Grandview Reserve Phases 2 & 3 Preliminary Plan & PUD Traffic Impact Analysis PUDSP-23-006 & PUDSP-24-001 (LSC #S234340) August 13, 2024

V3_TIS.pdf Markup Summary

DEVIATONS TO ECM CRITERIA

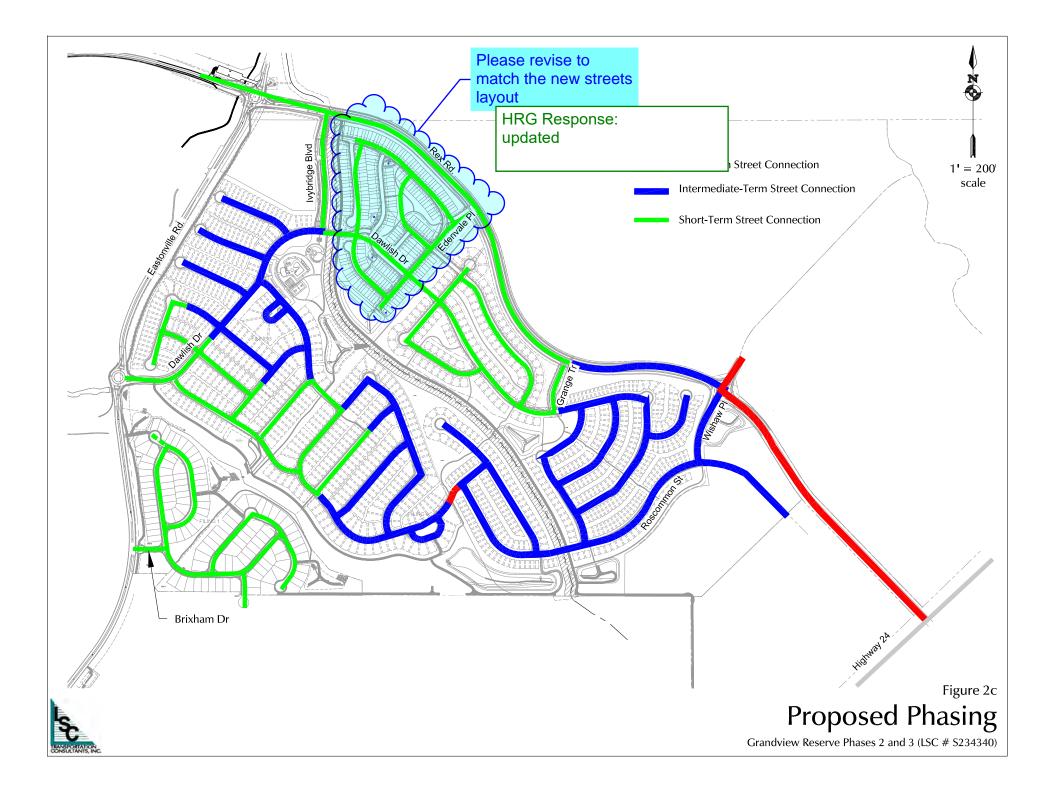
Please submit this deviation; did not see it with this round of
